PLANNING AND ZONING COMMISSION
 JANUARY 9, 2013 MEETING PACKET
 TABLE OF CONTENTS

STAFF REPORT AND RECOMMENDATION
PRELIMINARY PLAT – DRAKE GUNNISON PARTNERS, LLC

TO: Planning and Zoning Commission
From: Community Development Staff
Date: January 9, 2013
RE: Major Preliminary Subdivision SB 12-5, VanTuyl Village, Lot 80

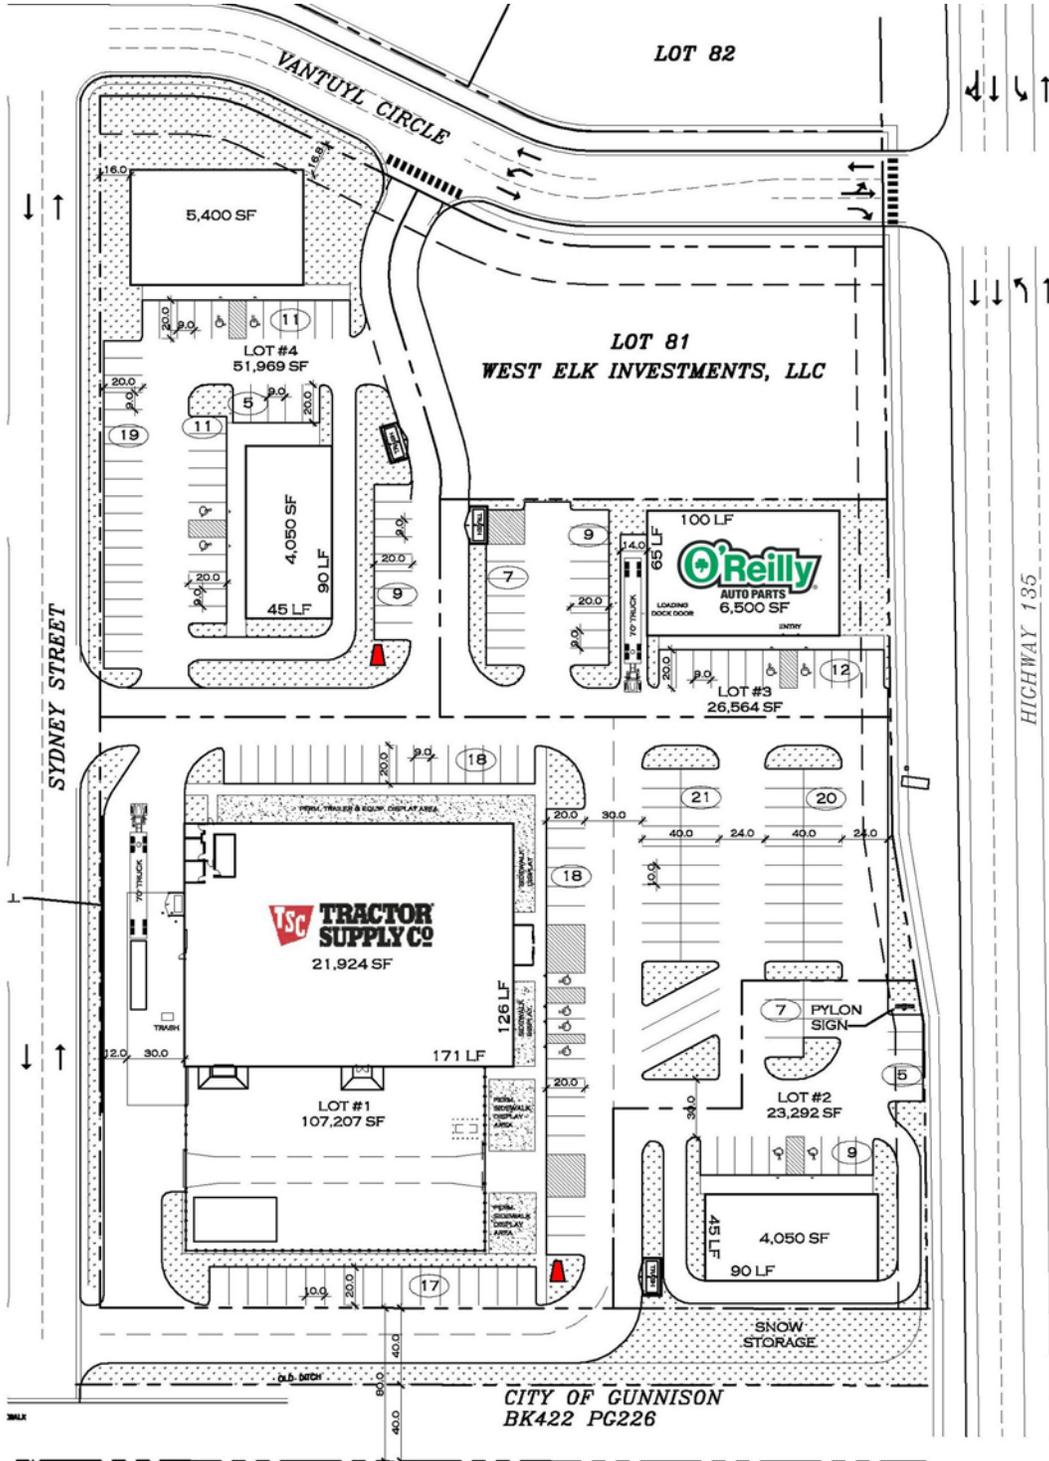
The Fire Marshall has indicated the need for one or two additional fire hydrants for the proposed development. The Fire Marshall has indicated the location of the hydrants (red or cone shaped symbols) in the conceptual site plan above.

Fire Marshal: Will need possibly one or two additional fire hydrants as indicated (red or cone shaped symbols) on the conceptual development plan above.

5. **Emergency Access.** Based on the Preliminary Plat, fire lane designs are compliant with the *International Fire Code*. A fire hydrant exists at the VanTuyl Circle/Highway 135 intersection. Final Plat documents will include two additional fire hydrants for internal service to the development. The location of the new fire hydrants has been specified by the Fire Marshall and indicated on the figure above (red or cone shaped symbols).

7. The Planning and Zoning Commission finds that Final Plat documents will include two additional fire hydrants for internal service to the development.
